FRIGIDAIRE SERVICE

Tech-Talk

Volume XII, No. 6

November 1960

Figure 1

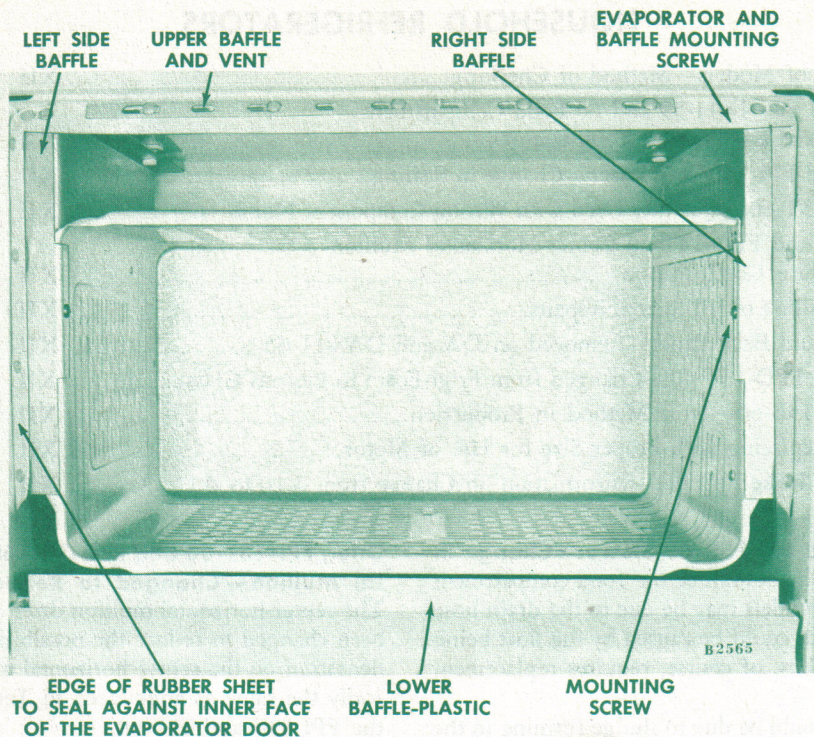
Baffle, D-13-59 and 60 and D-11-59 and 60 Food Compartment—Kit Available to Prevent Freezing Temperatures: A baffle kit, Piece No. 6590477, will be available early in June to prevent freezing temperatures in D-11-59 and 60 and in D-13-59 and 60 food compartments. This is accomplished by restricting the natural flow of air around the evaporator.

The kit is designed for 32" wide cabinets. To install on 28" cabinets, the top baffle assembly is shortened 2" on each end while the plastic baffle for the drip tray is shortened 4".

Figure 14

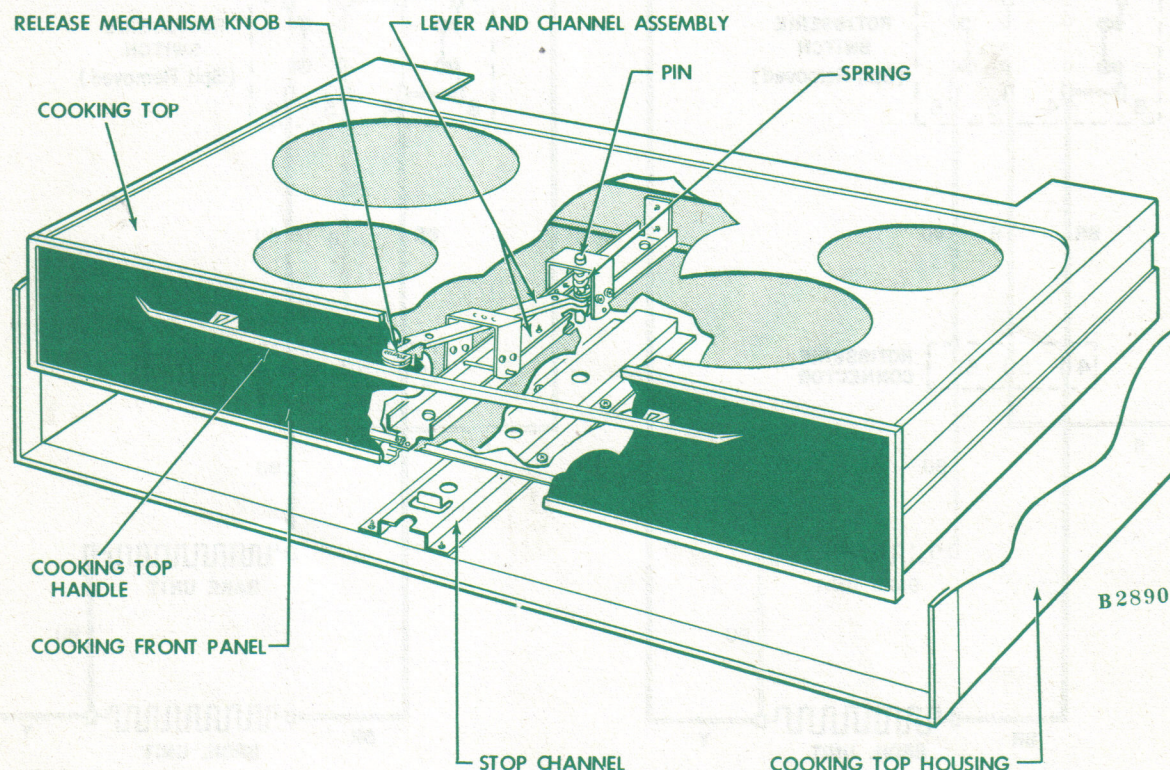
The release handle, formerly located above the cooking top cover at the left side of the range, now is positioned directly behind the center of the cooking top handle, Figure 14.

At the time the release knob is depressed, the pivoted latch lever moves downward at the front and upward at the rear. The upward movement depresses the latch pin operating spring. A retaining ring, mounted to the pin immediately below the spring, is in contact with the latch lever and, at the same time the spring is depressed, the latch pin is lifted free of the hole in the stop channel.

Figure 18

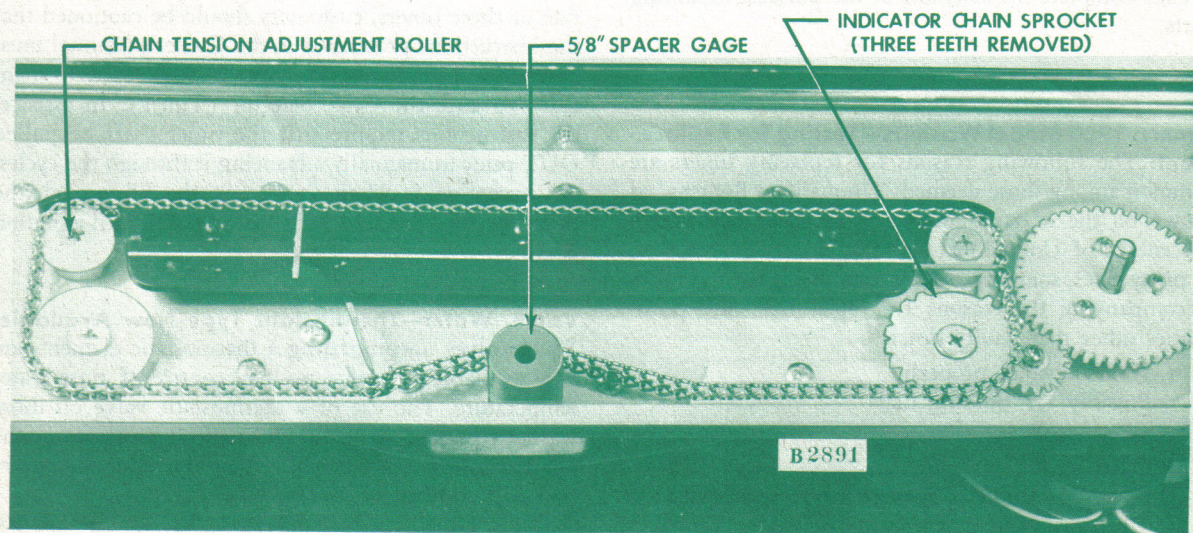
Cycle Selector, 1961 Custom Imperial Timers—Correction for Binding Indicator Chain: To correct the binding condition and provide proper tolerance for free movement of the 1961 Custom Imperial indicator chain, the following procedure is recommended:

1. Remove three teeth from the timer indicator chain sprocket as shown in Figure 6.
2. Remove the indicator chain and dip it into a solution of 2 to 3% vaseline in Trichlorethelene, Stoddard solvent or Napthalite. When using the latter two for dilution, proper care should be exercised in handling as these materials are flammable. Only a thin film of lubrication is required and, effective with October, 1960 production, indicator chains are being lubricated in production.

3. Reinstall the indicator chain on the rollers and position one of the three indicators to center over the location where the three gear teeth were removed. The indicator position must correspond to the eliminated center tooth location.

4. Rotate the timer dial drive gear to its alignment position and the indicator chain to its alignment position. Be sure the indicator chain tension adjustment roller is loose and then insert a piece of $\frac{5}{8}$ " O.D. pipe, wood dowel or metal rod, between the

bottom of the chain and the control mounting plate flange as a spacing gage as shown in Figure 18.

Figure 26

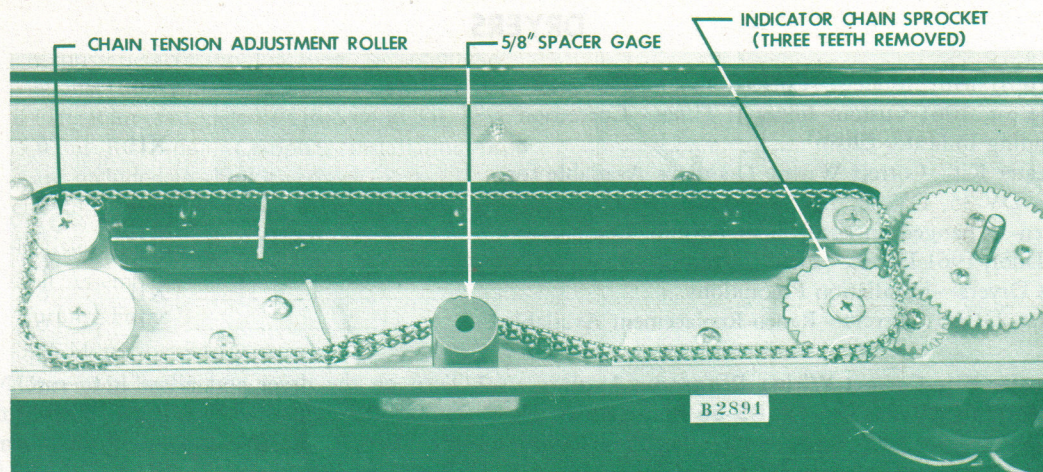
To correct the binding condition and provide proper tolerance for free movement of the 1961 Custom Imperial indicator chain, the following procedure is recommended:

1. Remove three teeth from the timer indicator chain sprocket as shown in Figure 26.
2. Remove the indicator chain and dip it into a solution of 2 to 3% vaseline in Trichlorethelene, Stoddard solvent or Napthalite. When using the latter two for dilution, proper care should be exercised in handling as these materials are flammable. Only a thin film of lubrication is required and, effective with October, 1960 production, indicator chains are being lubricated in production.
3. Reinstall the indicator chain on the rollers and position one of the three indicators to center over the location where the three gear teeth were removed. The indicator position must correspond to the eliminated center tooth location.
4. Rotate the timer dial drive gear to its alignment position. Be sure the indicator chain tension adjust-

ment roller is loose and then insert a piece of 5/8" O.D. pipe, wood dowel or metal rod, between the bottom of the chain and the control mounting plate flange as a spacing gage as shown in Figure 26.

Figure 27

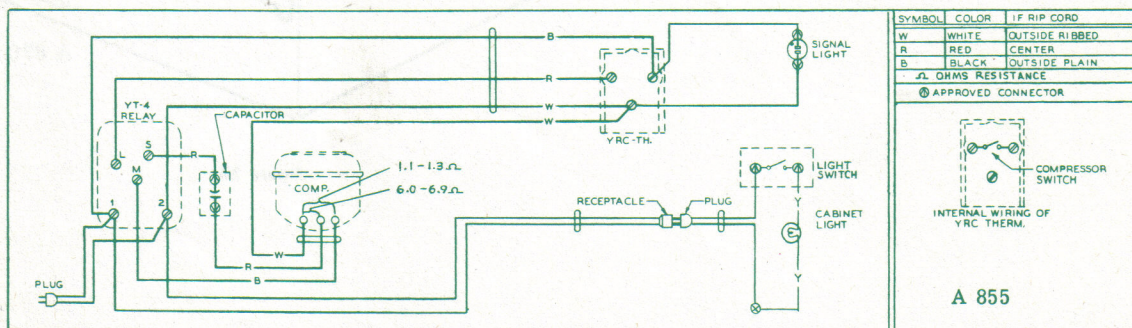
Approximately 500 CFB-20 Food Freezers were built using the YG-4 relay; those built after Serial No. 40AA9928 use the new relay. Model UFPI-16-60 and UFPD-16-60 Food Freezers will continue to use the YG-4 relay until the present production stock is depleted.

The accompanying figure shows the new CFB-20 wiring diagram.

Figure 28

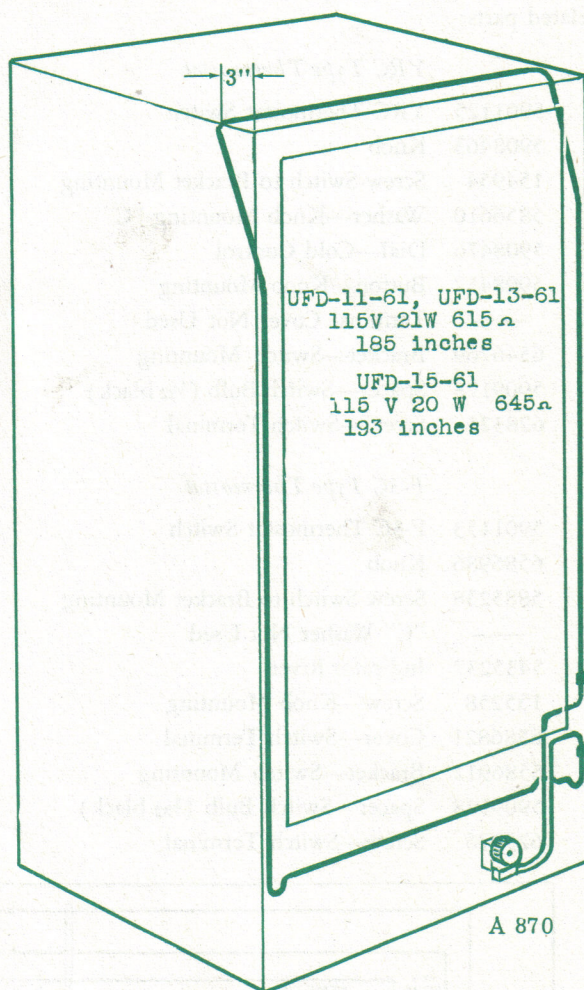
Shell Condensate, UFD-10 and UFD-12-60—Drier Shortened: Test models of the UFD-10-60 operated slightly warm in the area of the top door shelf. It was determined that this was due to a loop of condensate drier located behind the upper door opening molding. An immediate change was initiated to relocate the drier to contact the shell only. All production models of the UFD-10-60 were built this way. This led to a recheck of the UFD-12-60 performance and led to a similar change on this model.

The part number 6540875 shell drier has been shortened according to the above change. It must be installed the new way—without the loop behind the upper molding. This will affect earlier models of the 12 cu. ft. food freezers, UFD-123-58 and UFD-123-59. Refer to the following illustration for proper location of the shell drier.
